Flight Procedures Cover Page	Task Action: FLIGHT CHECK	Task Type: SID	Estimated Chart Date: 05/14/2026	APWS Task ID: C9C66A03695B4BC9A212B75C06CF607E	APWS Project ID: 22EA0654BB1F4F148F1F10A92F124413
Procedure: MAREO ONE (RNAV)		Enroute: YES	Specialist: Dudzinski, Lisa		Agreement Number:
Airport ID: KIND			Airport City: INDIANAPOLIS		State: IN
Facility ID:	Facility Type:	Flight Inspection Remark Type: New FC Slot			
<p>Procedure Comments:</p> <p>ACTIVE DATA USED FOR AIRPORT AND RUNWAYS.</p> <p>CONVERTED CURRENT MAREO FIVE SID INTO MAREO ONE (RNAV) SID.</p> <p>8260-1 WAIVER ON FILE: USING LESS ROC THAN REQUIRED FOR DP LEVEL OCS. 8260-1 WAIVER ON FILE: ATC REQUESTED MAINTAINED ALTITUDE LOWER THAN THE UNRESTRICTED CLIMB ALLOWED BY TERPS EVALUATION.</p> <p>CONTACT ALLAN WILL TRAINING SUBTEAM MANAGER AJV-A33 405-954-6103.</p> <p>1/16/26: THIS IS AN UPDATED COPY OF THE FORM DEVELOPED ON 11/07/25, WITH AFS REWORK.</p> <p>1. DEPARTURE ROUTE DESCRIPTION: REMOVED INDIVIDUAL AIRPORTS SERVED INSTRUCTIONS AND SIMPLY STATE: "ALL RUNWAYS: CLIMB ON ASSIGNED HEADING FOR VECTORS TO LUIJI ON TRACK 090.60 TO MAREO, THEN ON TRANSITION. MAINTAIN (JETS) 5000/(PROPS) 3000, EXPECT FILED ALTITUDE 10 MINUTES

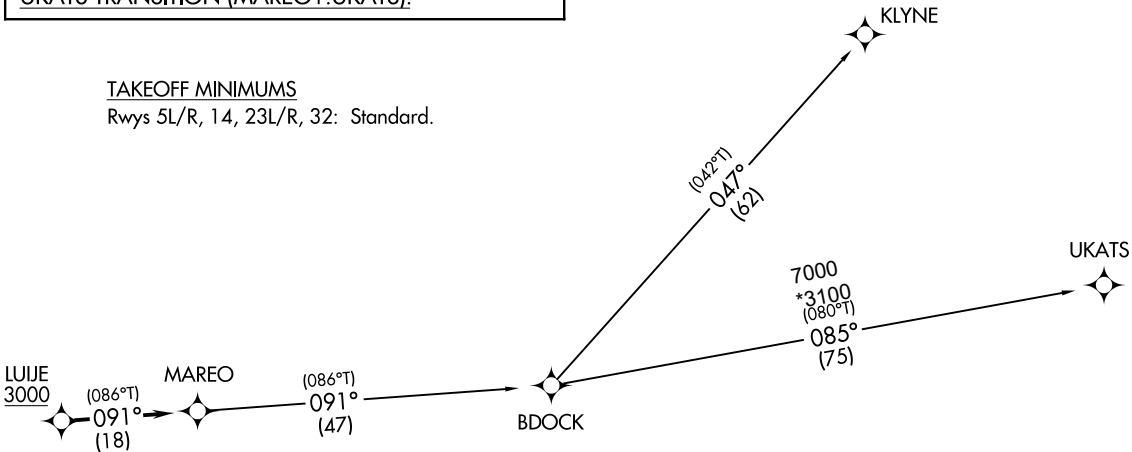
1. THE ENROUTE (LAST LEG) OF THE PROPOSED SID_BDOCK TO UKATS SHOULD HAVE THE MOCA CHARTED. SEE 8260.46K, PARAGRAPH 3-1-1.J.(2)(B) FOR MOCA GUIDANCE.

- COMPLETE -I HAVE PDF EDITED THE FIG TO SHOW THE MOCA/MEA.
